Device **TC26x**
Marking/Step **ES-BC, BC**
Package **see Data Sheet**

10212AERRA

This Errata Sheet describes the deviations from the current user documentation.

Figure 1 Message buffer transfer from Message RAM to OBF

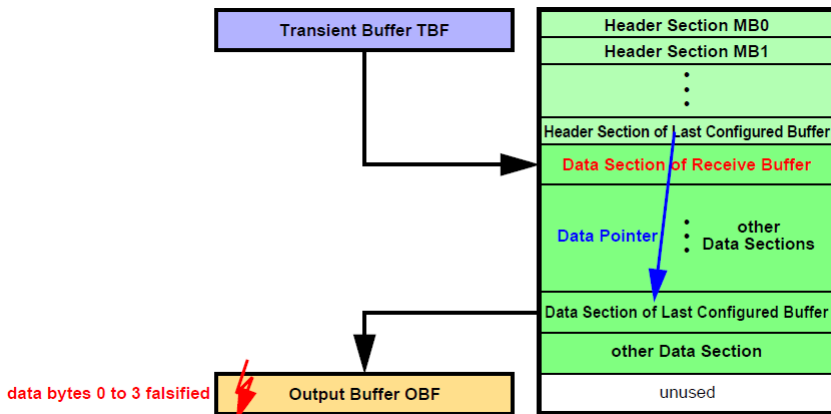
a) When a message is transferred from the Last Configured Buffer in the Message RAM to the OBF and **PLC** = 127 it may happen, that at the end of the transfer the OBF word on address 00h (payload data bytes 0 to 3) is overwritten with unexpected data (see [Figure 1](#)).

Figure 2 Message buffer transfer from IBF to Message RAM

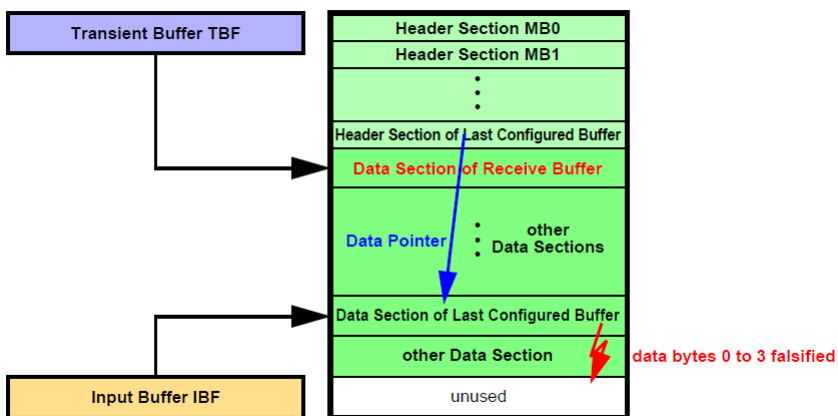
b) When a message is transferred from IBF to the Last Configured Buffer in the Message RAM, it may happen, that at the end of the transfer of the Data Section one additional write access overwrites the following word, which may be the first word of another message's Data Section in the Message RAM (see [Figure 2](#)).

Figure 3 Message RAM Configurations

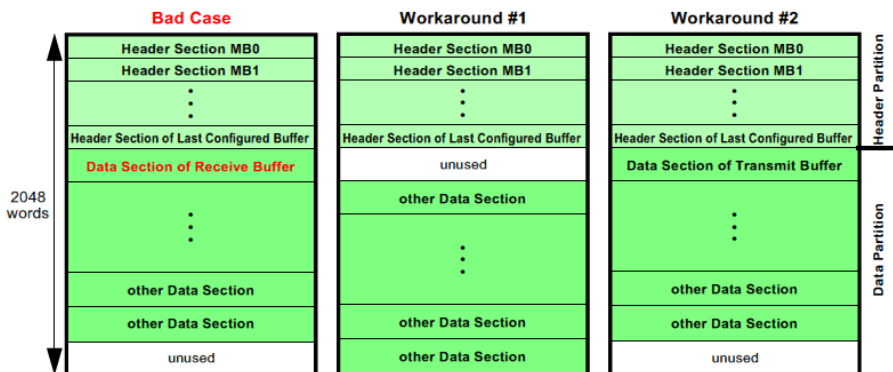
The erratum is limited to the case when (see [Figure 3](#) “Bad Case”):

2) Ensure that the Data Section directly following the Header Partition is assigned to a transmit buffer.

Figure 4 Example sequence showing how registers ETRRx may be filled with “Error Free” addresses

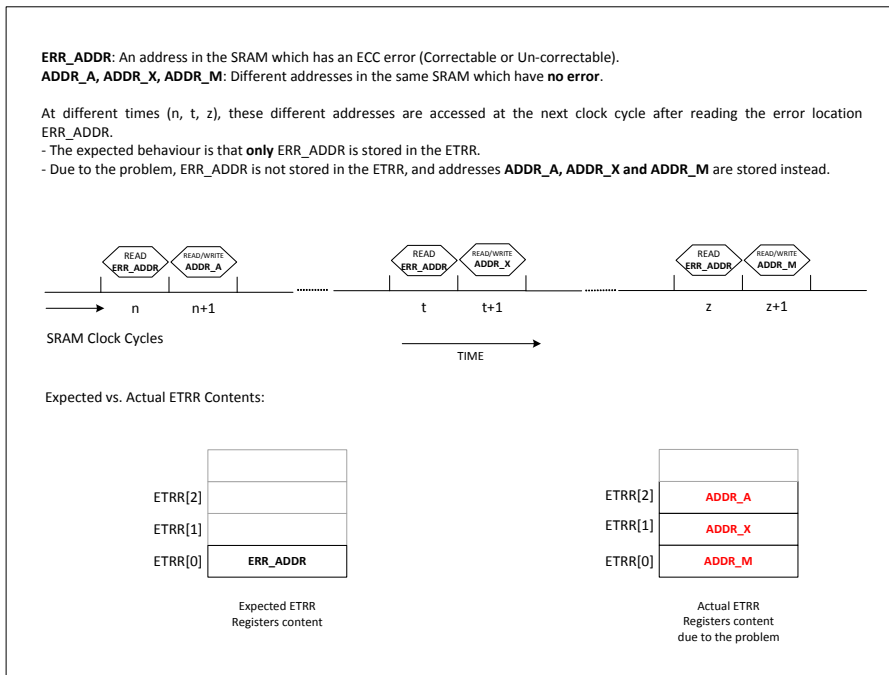
When such a consecutive access sequence (read from ERR_ADDR followed by read/write of different address(es)) happens multiple times, registers ETRRx are filled with addresses that have actually no error – and the SRAM address which actually has an error is not stored indeed. **Figure 4** shows such an example scenario.

The consequence of the scenario explained in **Figure 4** is that a single error in the SRAM – example just one correctable error at a location ERR_ADDR – can result in registers ETRRx getting filled with fault-free address, and thus potentially even triggering an ETRR overflow.

Figure 5 Recommended Software Handling - Flowchart

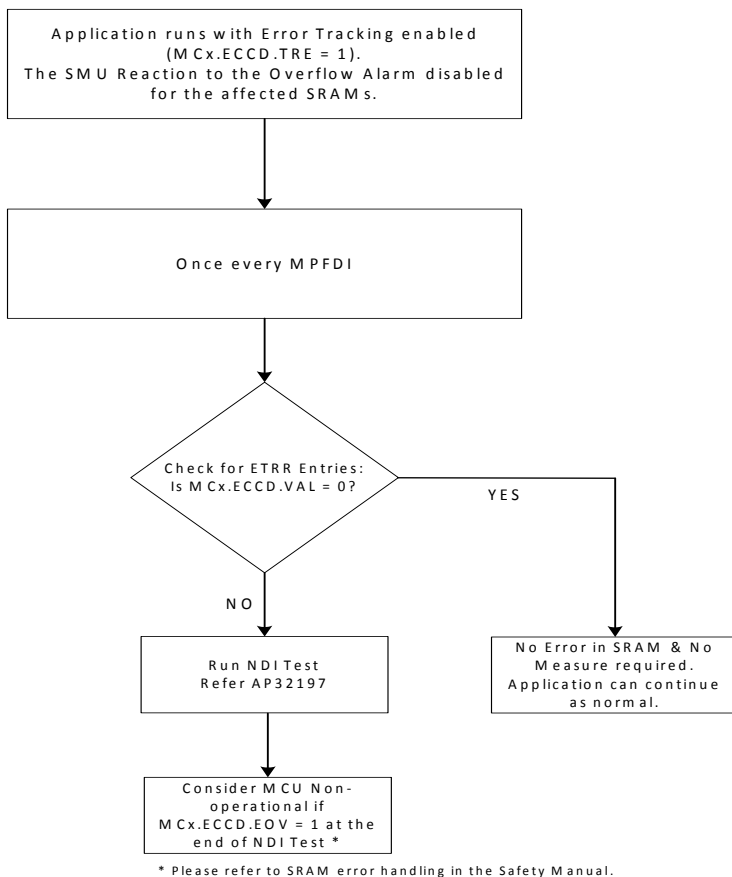
A flowchart of the recommended software handling is shown in [Figure 5](#).

If there is at least one valid ETRR entry (i.e. $MCx.ECCD.VAL \neq 0$) then the software shall run a Non-Destructive-Inversion (NDI) Test on the affected SRAM. Please refer to application note AP32197 (AURIX™ Memory tests using the MTU) for an example regarding running this test.

At the end of this test, if an ETRR overflow is detected ($MCx.ECCD.EOV = 1_B$) then the MCU shall be considered non-operational. Refer to section on Correctable SRAM Error handling in the Safety Manual.

Figure 14 Ripple Voltage vs. Frequency Characteristic

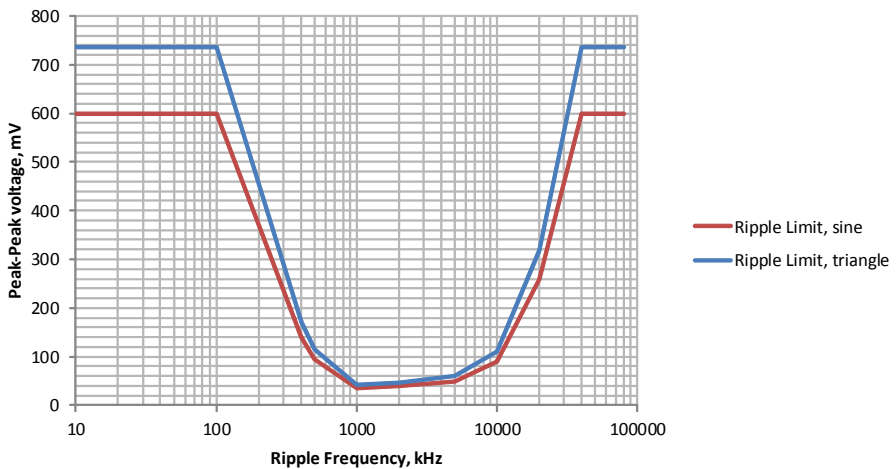
The internal back-up clock is sensitive to specific power supply voltage disturbance/ripple caused by a voltage ripple intrinsic to DC-DC converters. Specific conditions such as insufficient filtering of the ripple may lead to improper behavior of the start-up scheme of the back-up clock, and thus stuck-at state during the start-up of the microcontroller until this condition is removed.

The acceptable voltage vs. frequency characteristic is portrayed below on the chart:

Figure 16 SENSE Tolerance of this Design Step

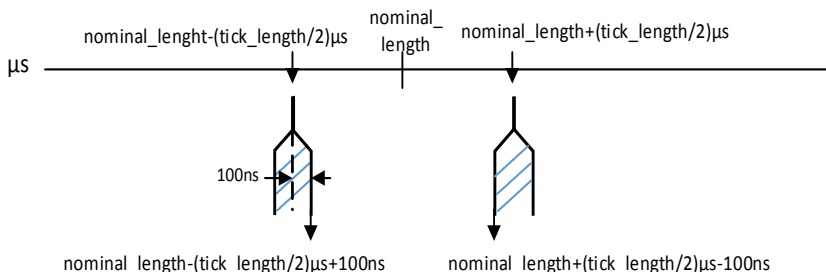
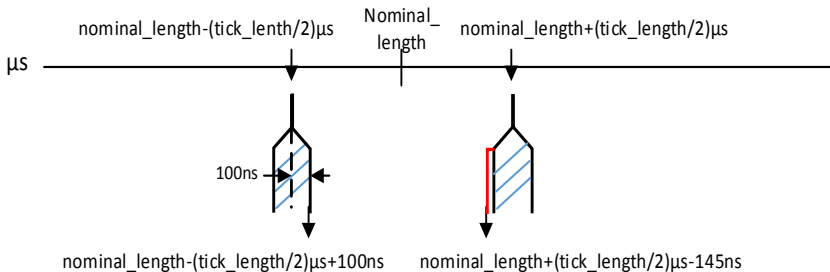
The length of a nibble in the SENT protocol determines the value of this nibble. For each value this length can vary, but it has to be at least inside a given range. This range is given by the SENT standard.

In this design step the range is delimited as follows:

- The lower border is $\text{nominal_value} - (\text{tick_length}/2) \mu\text{s} + 100 \text{ ns}$
- The upper border is $\text{nominal_value} + (\text{tick_length}/2) \mu\text{s} - 145 \text{ ns}$.

Figure 17 Short Serial Message, Serial Data Encoding over 16

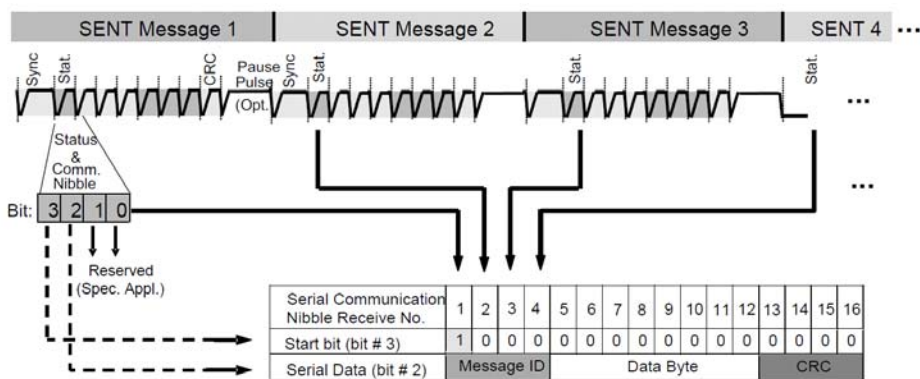
In Figure “Short Serial Message, Serial Data Encoding over 16 messages” of the SENT chapter, the arrows originating from bits 2 and 3 of the Status & Comm Nibble are routed incorrectly and must be swapped.

Figure 17 shows a corrected version of this figure.
